Product / Process Change Notification (PCN)

PCN Number: PCN_AsHST_20241023

Affected Series: WA-HST

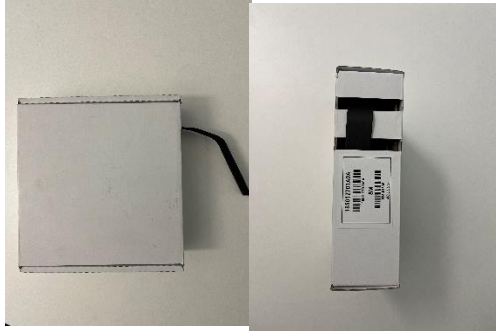
For improved transportation and handling safety, Würth Elektronik eiSos is going to change the packaging. There will be no change in form, fit, function, quality or reliability of the product. The new revision of the affected order codes will be sent out after the previous revision is out of stock (according to FIFO - first-in, first-out).

The new packaging will look like showed in the pictures below.

Before Change	After Change
Carton Length:	-	17.00 cm
Carton Width:	-	05.50 cm
Carton Height:	-	18.00 cm
Picture:

The new carton is smaller than the bag, therefore the SPQ will change, see below:
